**Addendum (Revision 1) to Remedial Action Options Report (RAOR)  
and Pre-Design Sampling Work Plan - Connell Aluminum Properties, LLC  
Former Koppers Tar Plant and Wabash Alloys Site  
9100 S. 5<sup>th</sup> Avenue, Oak Creek, WI 53154  
BRRTS# 02-41-553761, FID#241379050  
Connell VPLE BRRTS #:06-41-560068**

January 11, 2021

**City of Oak Creek Utility Corridor Lot 1  
9170 South 5<sup>th</sup> Avenue, Oak Creek, WI 53154  
BRRTS#: 02-41-561425, FID #:341074470  
VPLE BRRTS#: 06-41-561426**

This Addendum (R1) letter addresses the WDNR's comment letter dated October 25, 2017 and the additional June 10, 2020 comment letter provided to Connell upon WDNR's review of the March 13, 2020 Addendum regarding *Review of Site Investigation and Remedial Action Options Reports, Former Koppers Tar Plant and Wabash Alloys Facility*. On July 7, 2020, Connell participated in a conference call with the WDNR in which we discussed our proposal for revising the Addendum to address the WDNR's June 2020 comments. We discussed increasing the cap extents in several areas to closely match the extents planned by Beazer for capping the creosote-impacted (PAHs) soil, for which WDNR did not have an objec

**FIGURE 6**  
FIGURE C35 (REV. SI REPORT)

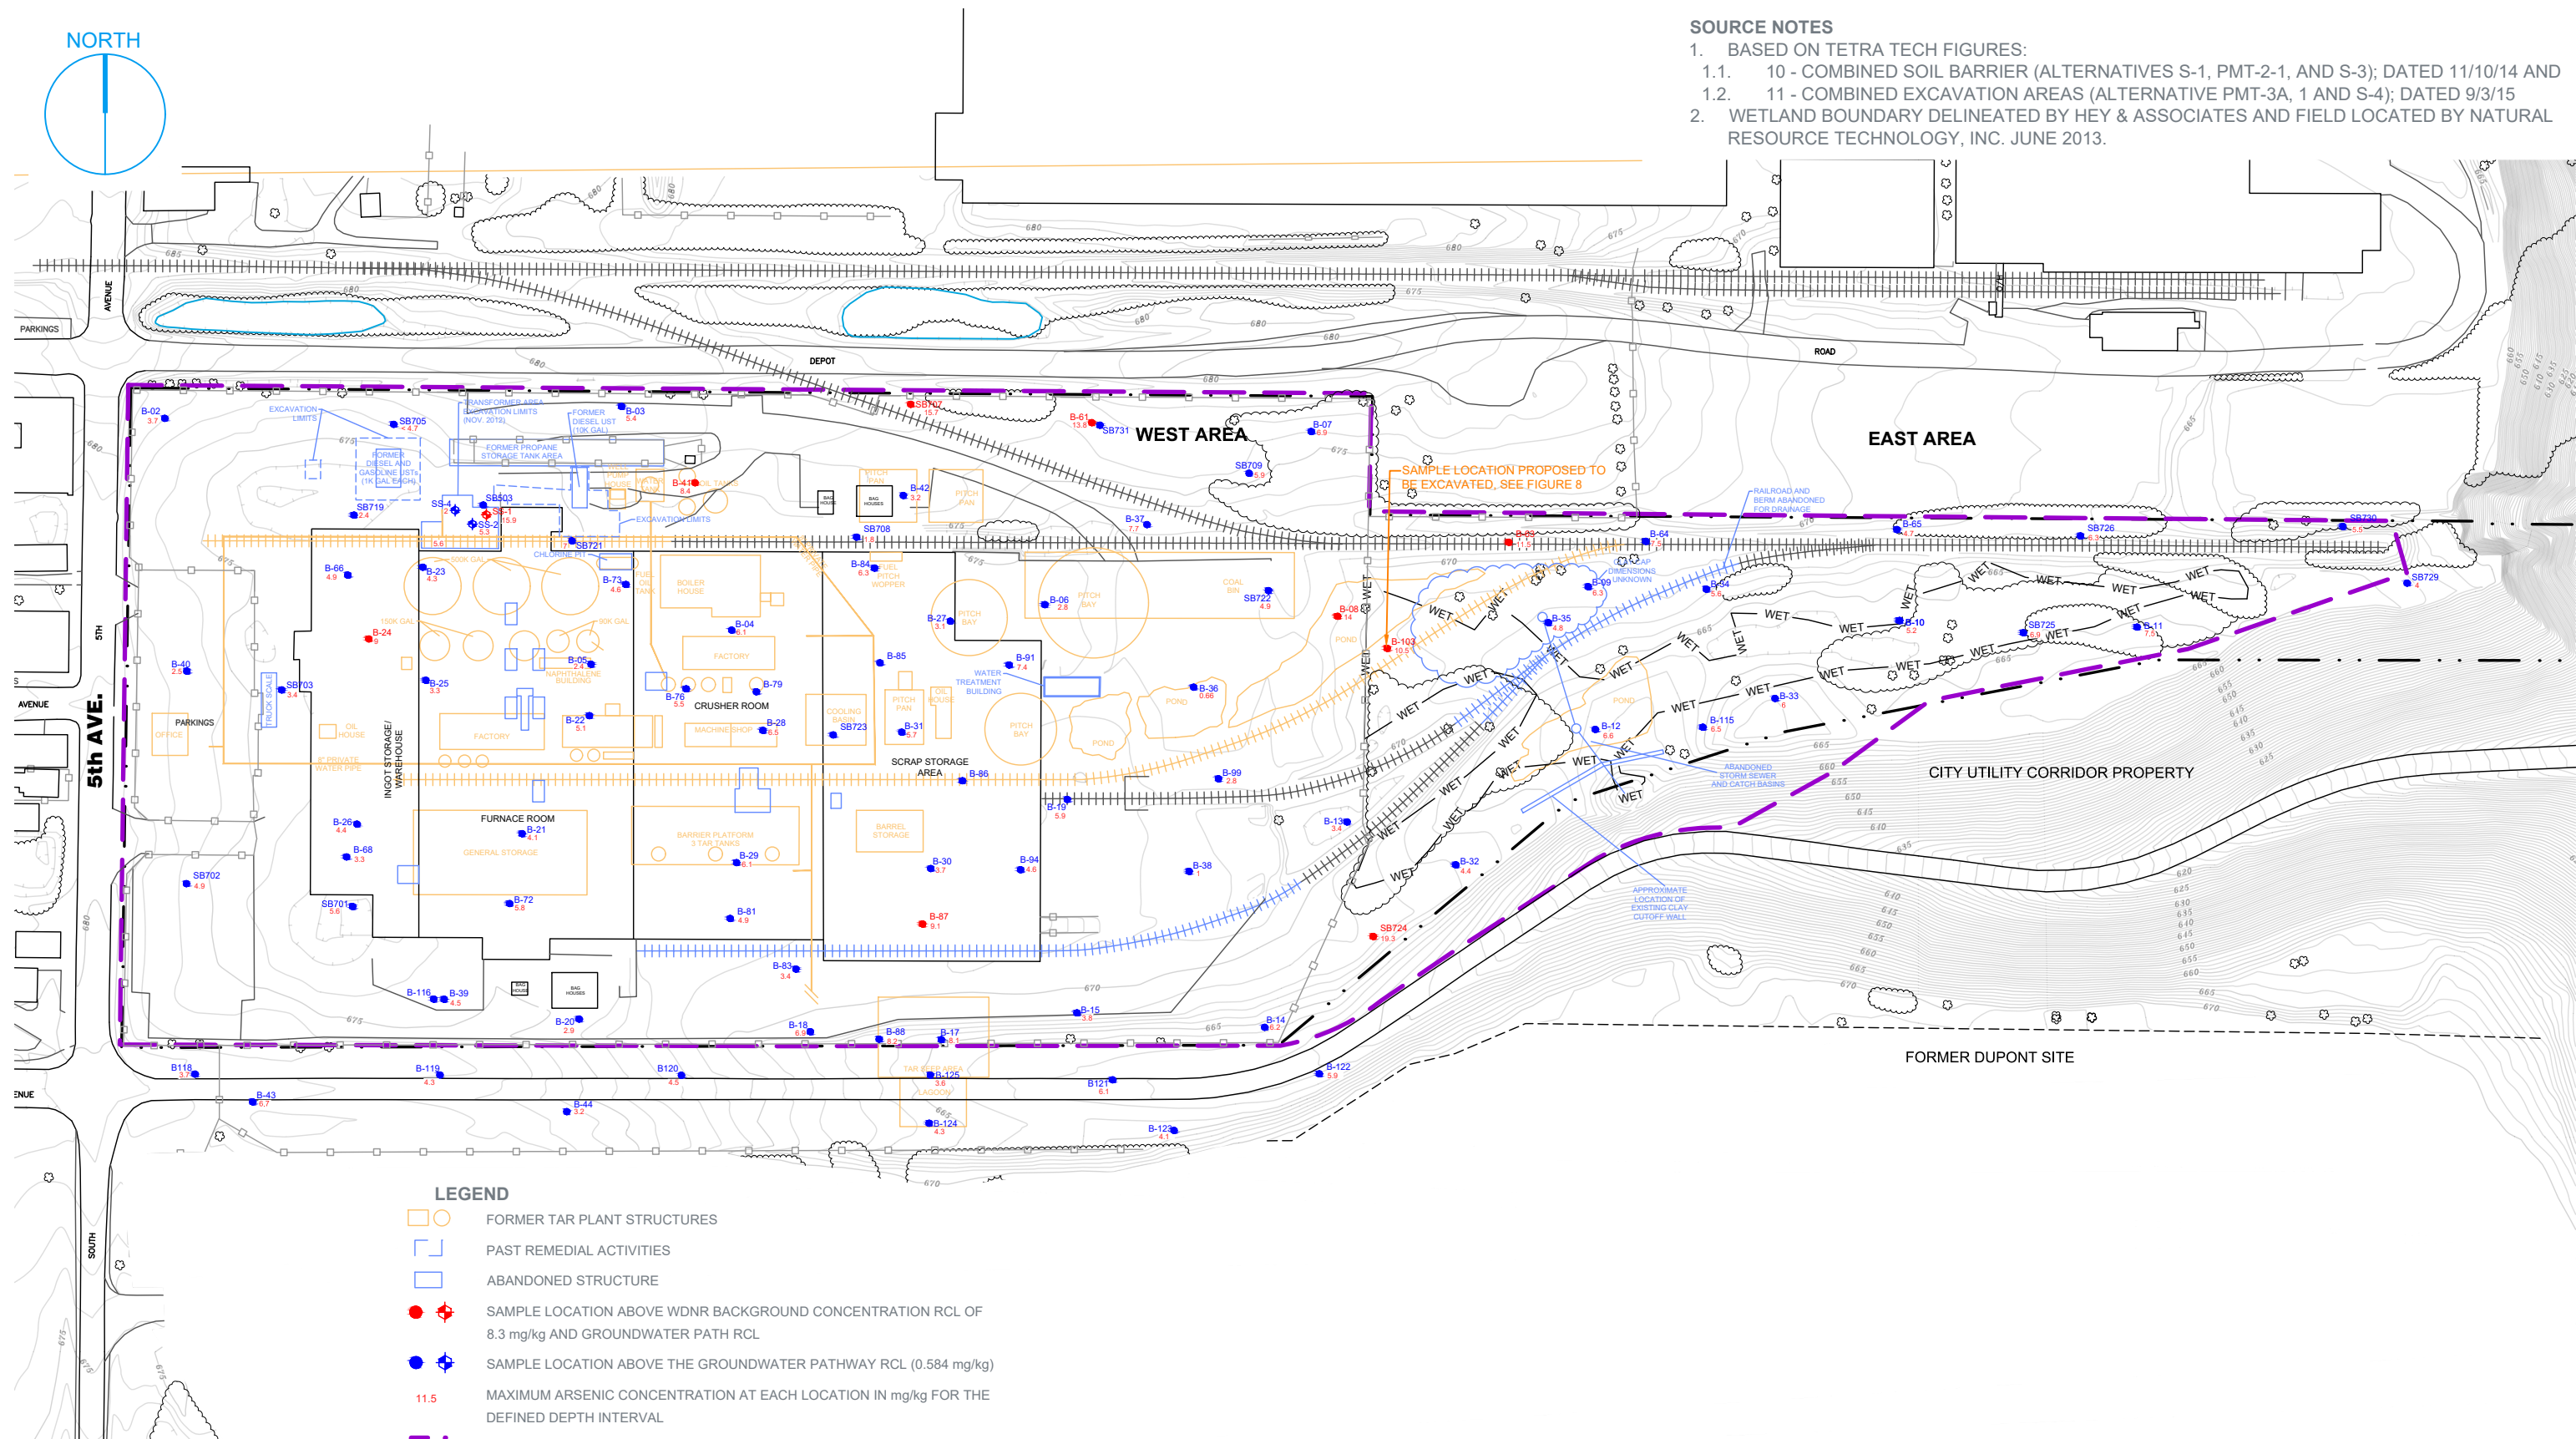
- Figure 5 – Revised RAOR Figure 8 - PCB and Arsenic Soil Barrier (Alternative S-3) for purposes of showing the revised estimated cap extent in both the western and eastern areas.
- Figure 6 – Revised Figure C35 SI Report – PCB Aroclor 1242/1248/1254/1260 Soil Concentrations (0-4 feet bgs) for purposes of showing PCB sampling results and proposed cap extents.
- Figure 7 – Revised Figure C1 SI Report – Arsenic Soil Concentrations (0-4 ft bgs) for purposes of showing arsenic sampling results and proposed cap extents.

**FIGURE 8**

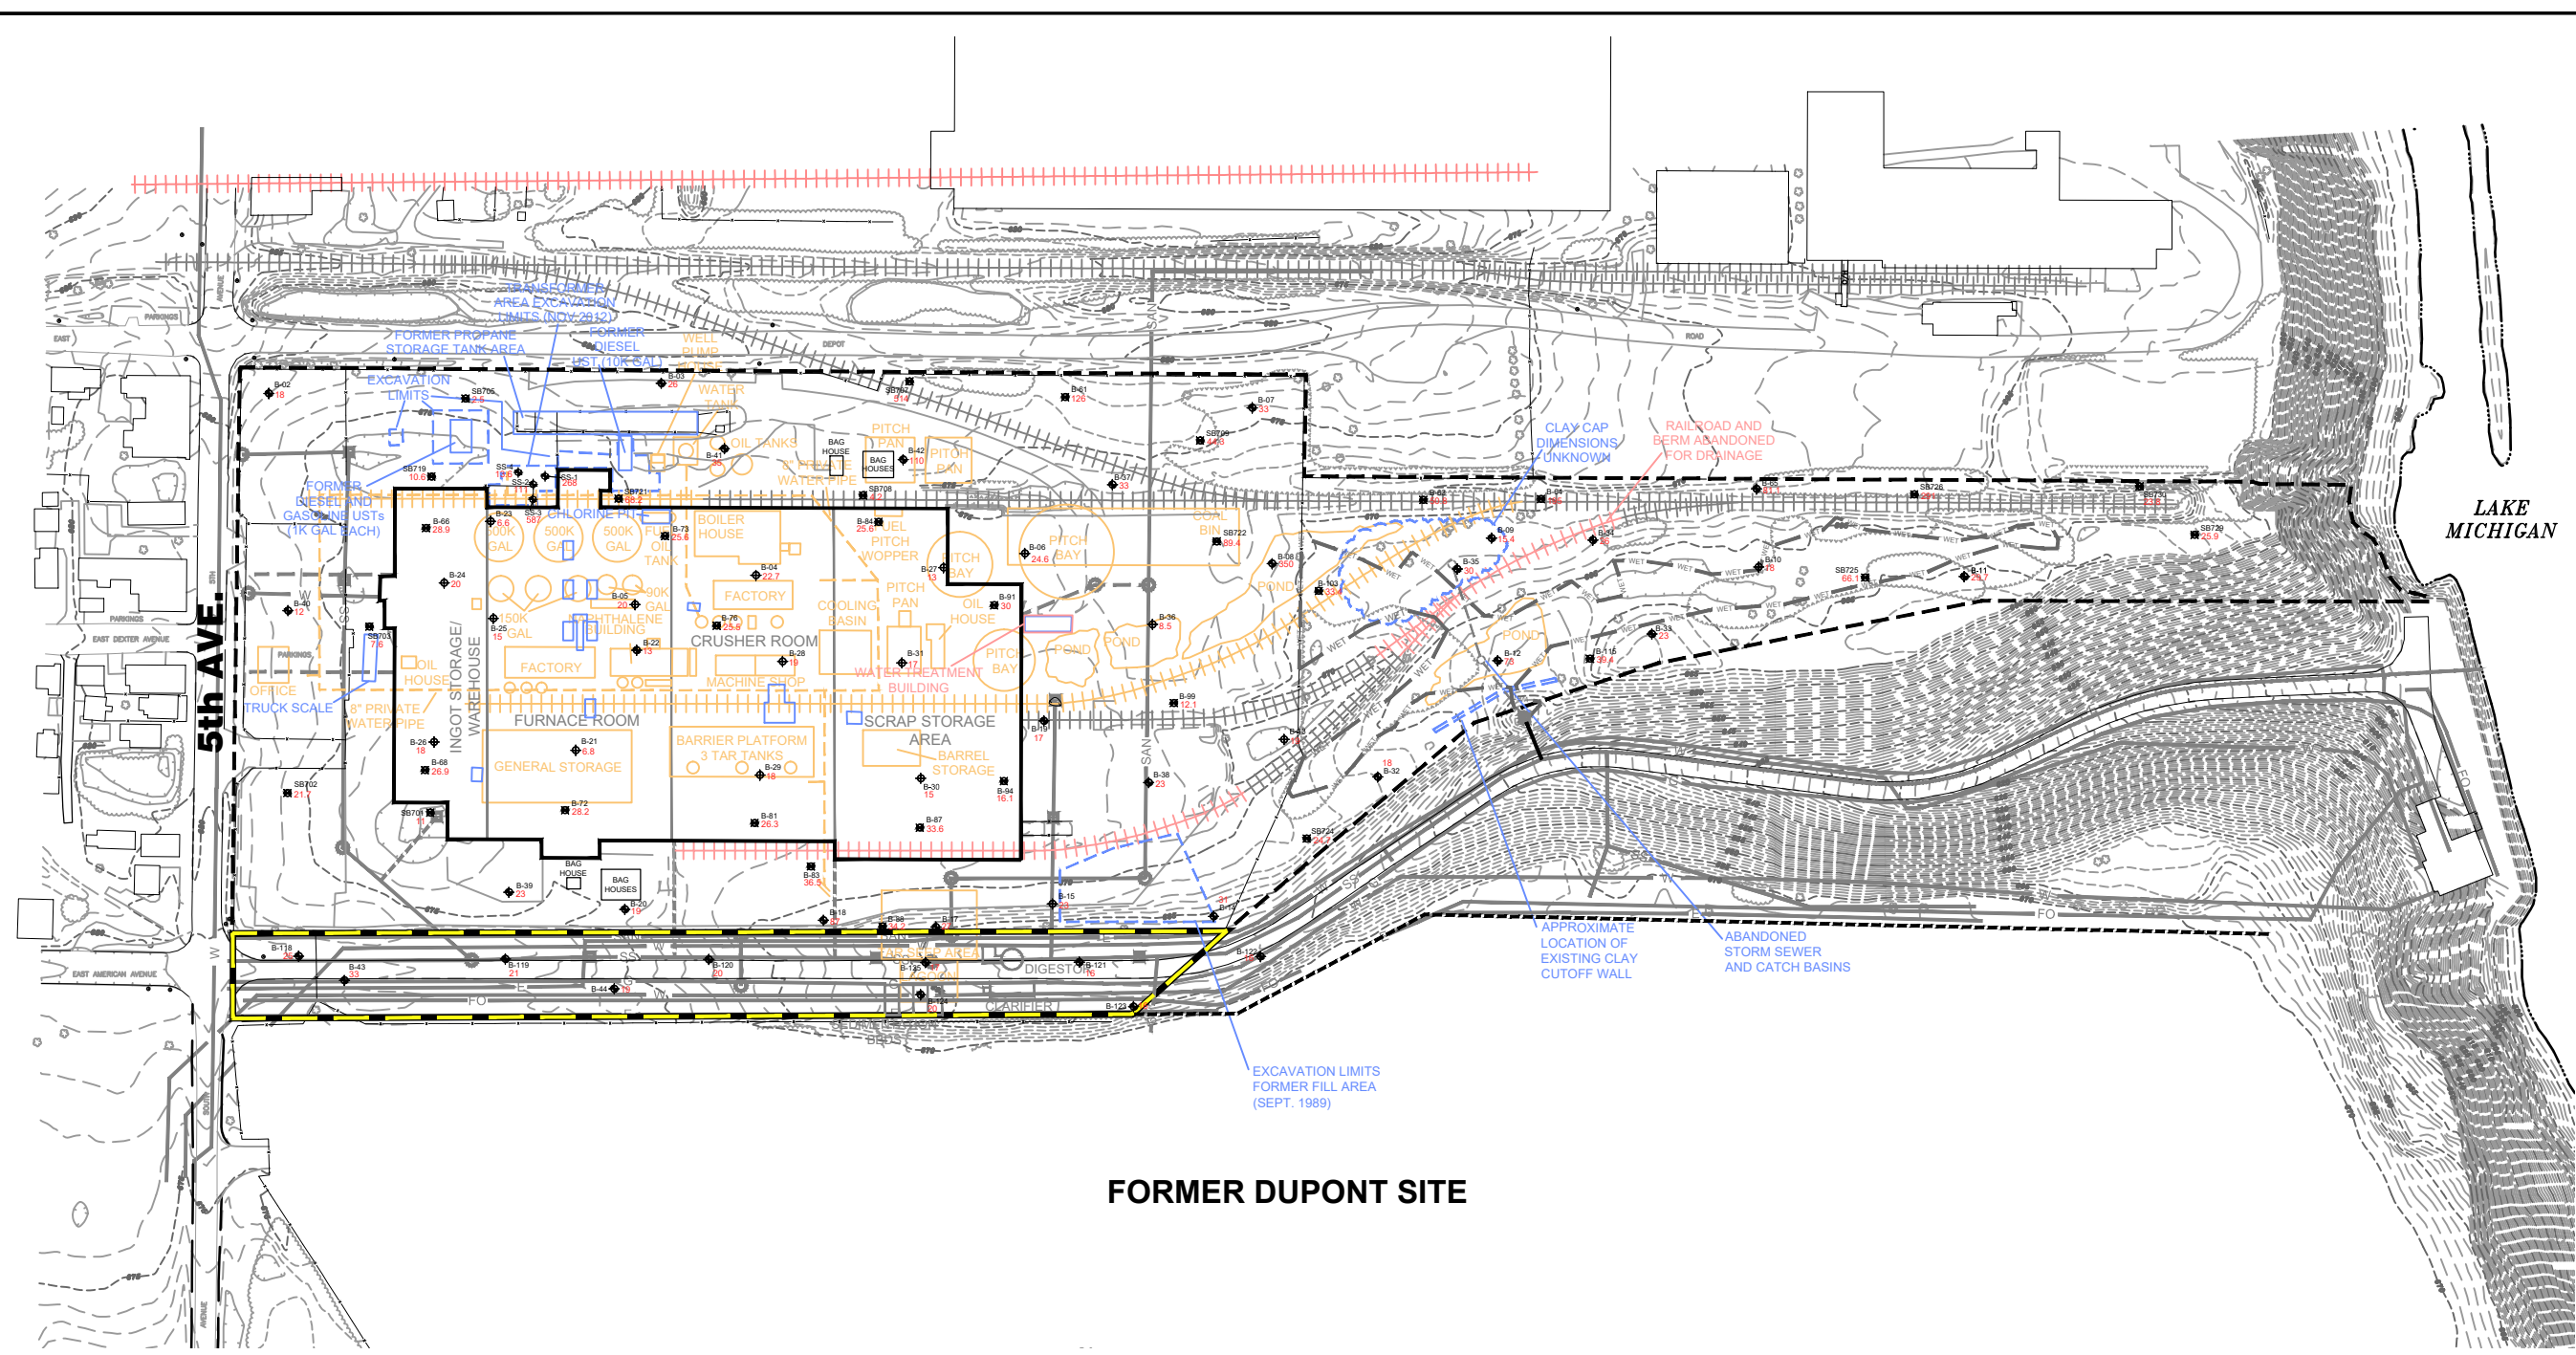
Ramboll has prepared a new figure (Figure 8) to illustrate the additional proposed capping extent in the eastern area, to include both wetland and non-wetland areas that exceed respective non-industrial RCLs.

- Figure 8 – PCB and Arsenic Soil Barrier – East Area for purposes of showing the additional proposed cap extent. The additional pre-design PCB sampling locations related to comments C7 and C8 are shown (8 borings labeled SB741 to SB748). Four of the sampling locations are proposed to be performed on the City Utility Corridor property, and as such, access for these will be requested from the City. WDNR comments C1 through C6 are not applicable as the cap is being extended to the property boundary or beyond to the City property in these areas, and largely coincides with the proposed cover for PAHs (Beazer plans).

Soil borings are planned in the southeastern corner of the proposed cap (near the boundary of the City and Connell properties) with samples to be collected in 2-foot intervals (both 0-2 ft, 2-4 ft) for PCB analysis as done previously (Table 1). Borings will be advanced to 4 feet total depth. The sample results will be used to refine the cap extent that is required for PCBs to be shown in the Remedial Design Report, where appropriate (the cap is not required for arsenic in these locations and therefore samples are not proposed to be analyzed for arsenic).
